Wahib Medanat Consultant Engineers Consultant Site Name Um Al Dananir Basic Mixed - Balga

Rep No. QC-11 10

Description of Non Conformance

Steel Reinforcement

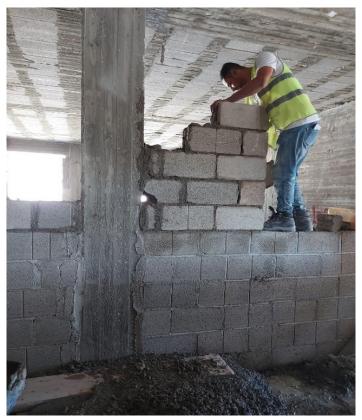
- 2. Building of block walls without using fixationaccessories.
- 3. Building stones which do not comply with the approved sample in relation to the length and
- 4. Steel reinforcement stock at site rusted, oil on surface and other
- 5. Plastering work without surface preparation.

4. Sandblasting for the steel
